Report on Submissions relating to Plan Change 12:

Integrated transport Management

Report Number:	100012
To:	Hearing Commissioner
From:	David Hattam
Hearing Dates:	16-17 April 2012

Diagram E13.2 (Township) and E10.A1 (Rural) - Sight Distance Measurement and State Highway/Arterial sight distance values.

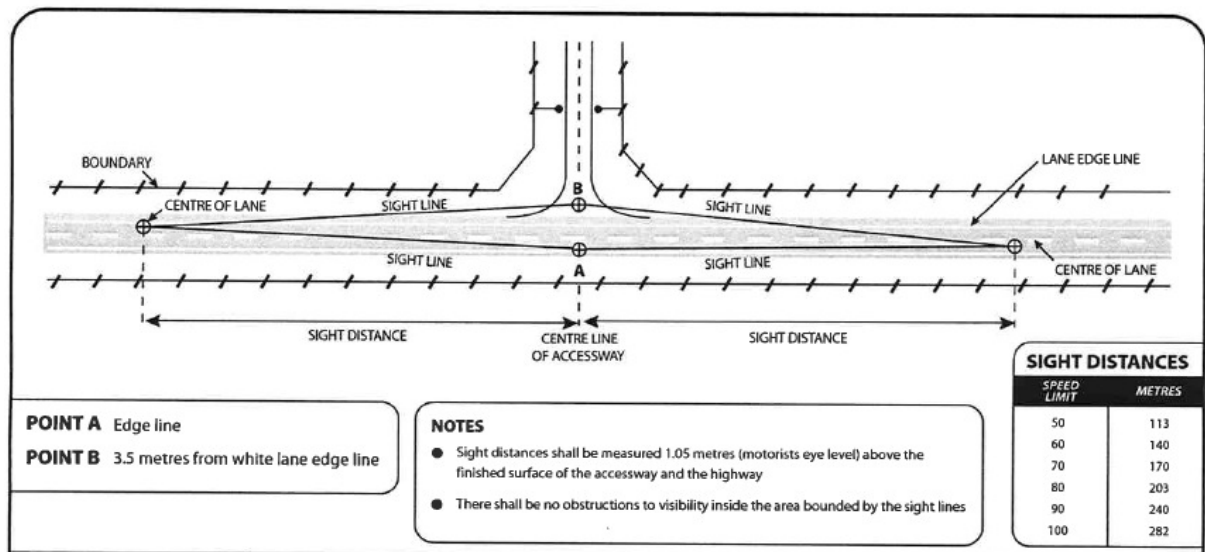
Submitter 25 (25.12) considered that sight distances are inappropriate and inconsistent with the NZTA Planning Policy Manual which states that the 85th percentile speed should be used. These equate to sight distances 50% of those specified in table E10.4. Requests update of table E10.4 and Diagram E10.A1 to match NZTA Planning Policy Manual. The submitter requested that non compliance with sight distances in table E13.2.3 should be restricted discretionary rather than discretionary (rule 5.3.6).

Ms Williams has discussed sight distances in appendix 3. As she notes, the adopted sight distances are the same as those provided in the NZTA Planning and Policy Manual.

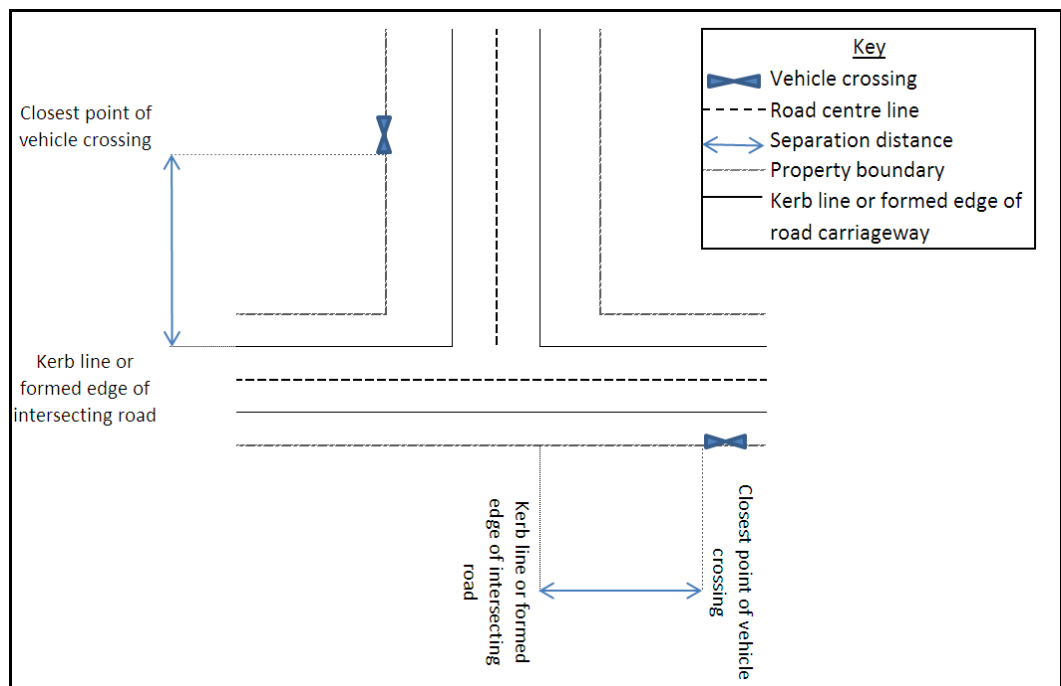
Submitter 25 (25.11 and 25.15) requested amendments to the Table 10.6 (rural), E13.5 and E13.9 (township). He notes that the principle is that lower classification roads can have lower intersection spacing. However, he notes that this is not always reflected in the tables which are based on the NZTA Planning Policy Manual.

Ms Williams considers this submission in appendix 3 and notes that some of the numbers in the tables were transposed incorrectly. She also agrees that other changes reflecting the contents of the submission can be made. She has provided amended tables and a diagram to provide clarity on how the tables are to be interpreted. The diagram replaces E10.A2 and E13.4 as notified and is reproduced below (under recommendations).

Replace table E10.3 and Diagram E10.A2 (Rural Volume, Appendix E10) and Table E13.5 and Diagram E13.4 (Township Volume, Appendix E13) with the following:

That the following diagram replace that previously notified to clarify the application of the rule:

Diagram E13.2 (Township) and E10.A1 (Rural) - Sight Distance Measurement and State Highway/Arterial sight distance values.

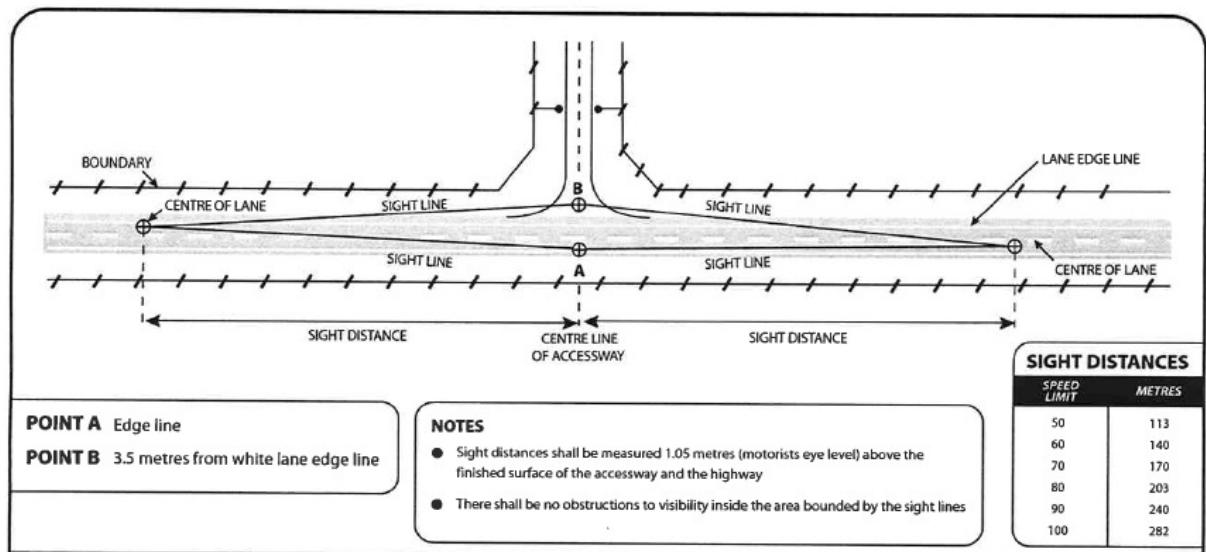
Submitter 25 (25.12) considered that sight distances are inappropriate and inconsistent with the NZTA Planning Policy Manual which states that the 85th percentile speed should be used. These equate to sight distances 50% of those specified in table E10.4. Requests update of table E10.4 and Diagram E10.A1 to match NZTA Planning Policy Manual. The submitter requested that non compliance with sight distances in table E13.2.3 should be restricted discretionary rather than discretionary (rule 5.3.6).

Ms Williams has discussed sight distances in appendix 3. As she notes, the adopted sight distances are the same as those provided in the NZTA Planning and Policy Manual.

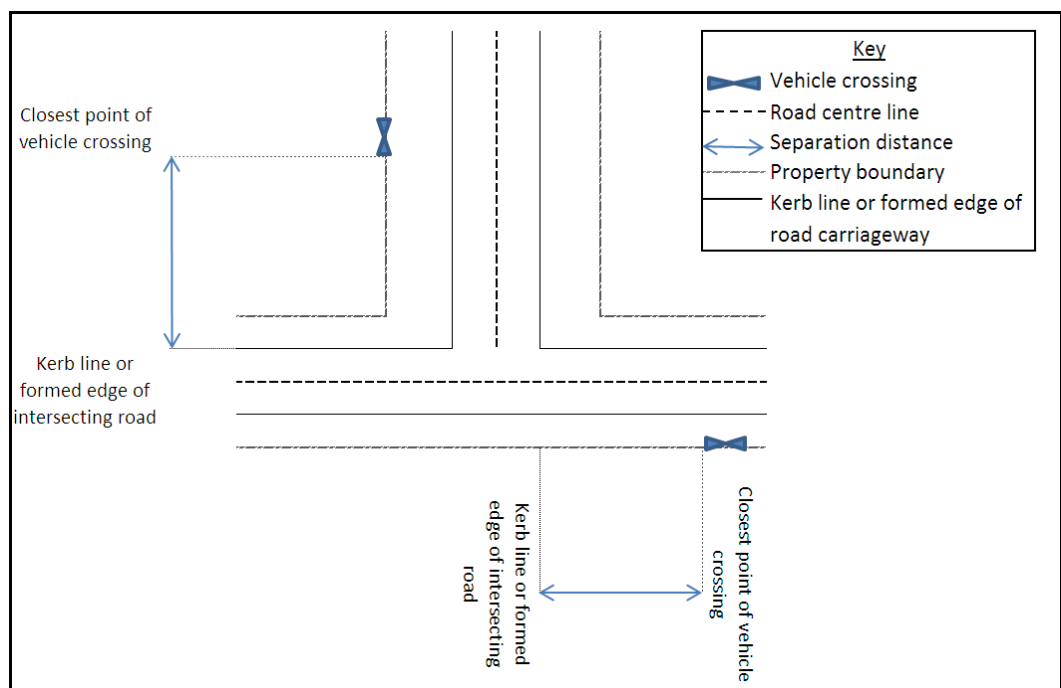
Submitter 25 (25.11 and 25.15) requested amendments to the Table 10.6 (rural), E13.5 and E13.9 (township). He notes that the principle is that lower classification roads can have lower intersection spacing. However, he notes that this is not always reflected in the tables which are based on the NZTA Planning Policy Manual.

Ms Williams considers this submission in appendix 3 and notes that some of the numbers in the tables were transposed incorrectly. She also agrees that other changes reflecting the contents of the submission can be made. She has provided amended tables and a diagram to provide clarity on how the tables are to be interpreted. The diagram replaces E10.A2 and E13.4 as notified and is reproduced below (under recommendations).

Replace table E10.3 and Diagram E10.A2 (Rural Volume, Appendix E10) and Table E13.5 and Diagram E13.4 (Township Volume, Appendix E13) with the following:

That the following diagram replace that previously notified to clarify the application of the rule:

Diagram E13.2 (Township) and E10.A1 (Rural) - Sight Distance Measurement and State Highway/Arterial sight distance values.

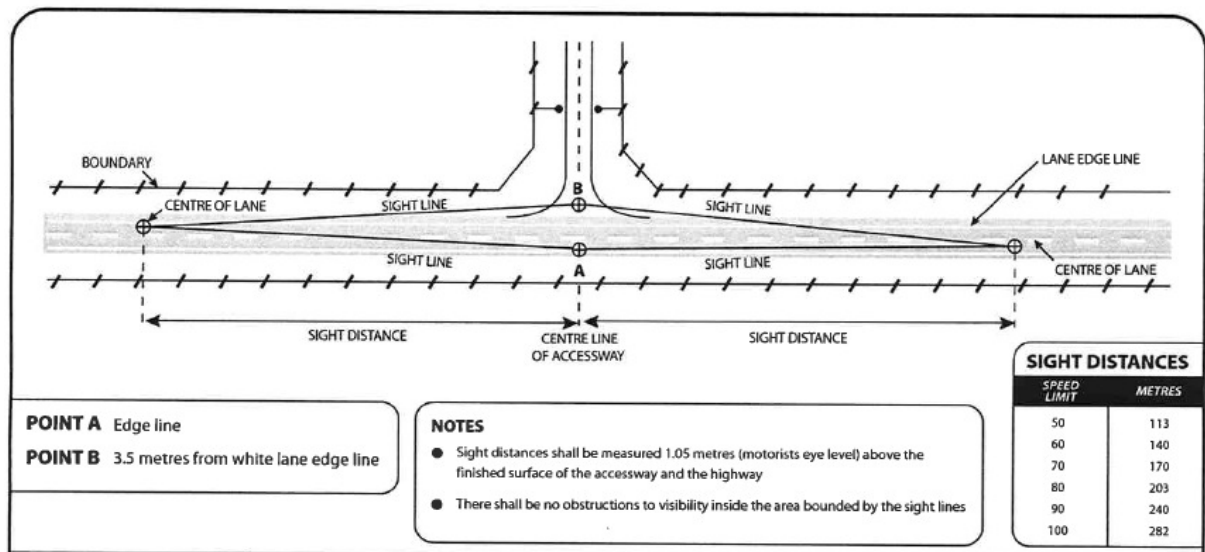
Submitter 25 (25.12) considered that sight distances are inappropriate and inconsistent with the NZTA Planning Policy Manual which states that the 85th percentile speed should be used. These equate to sight distances 50% of those specified in table E10.4. Requests update of table E10.4 and Diagram E10.A1 to match NZTA Planning Policy Manual. The submitter requested that non compliance with sight distances in table E13.2.3 should be restricted discretionary rather than discretionary (rule 5.3.6).

Ms Williams has discussed sight distances in appendix 3. As she notes, the adopted sight distances are the same as those provided in the NZTA Planning and Policy Manual.

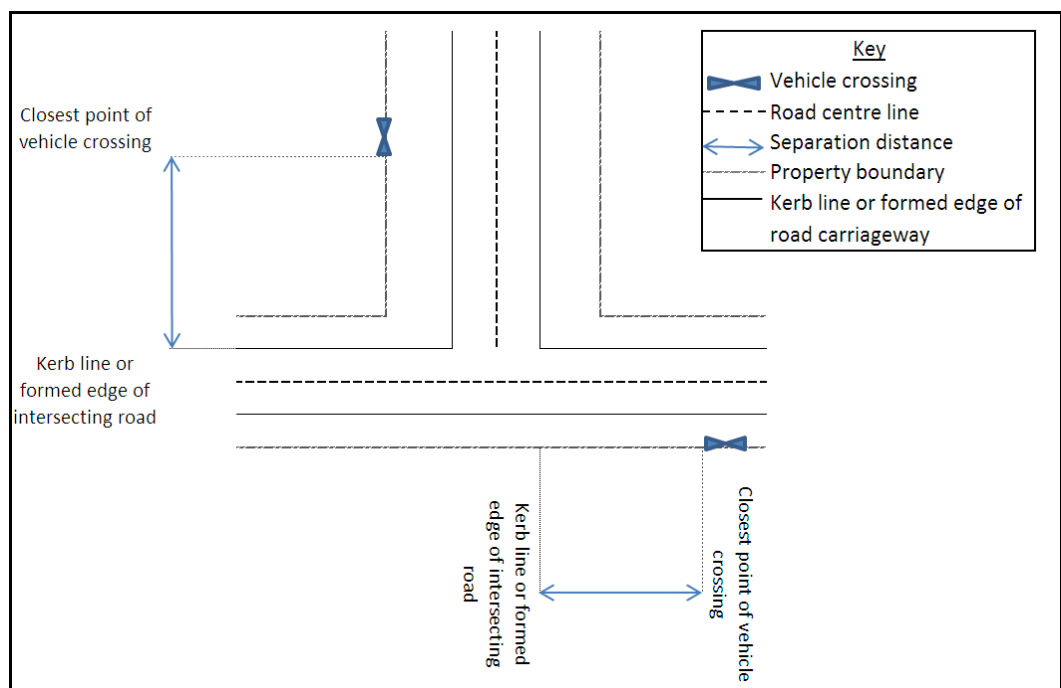
Submitter 25 (25.11 and 25.15) requested amendments to the Table 10.6 (rural), E13.5 and E13.9 (township). He notes that the principle is that lower classification roads can have lower intersection spacing. However, he notes that this is not always reflected in the tables which are based on the NZTA Planning Policy Manual.

Ms Williams considers this submission in appendix 3 and notes that some of the numbers in the tables were transposed incorrectly. She also agrees that other changes reflecting the contents of the submission can be made. She has provided amended tables and a diagram to provide clarity on how the tables are to be interpreted. The diagram replaces E10.A2 and E13.4 as notified and is reproduced below (under recommendations).

Replace table E10.3 and Diagram E10.A2 (Rural Volume, Appendix E10) and Table E13.5 and Diagram E13.4 (Township Volume, Appendix E13) with the following:

That the following diagram replace that previously notified to clarify the application of the rule:
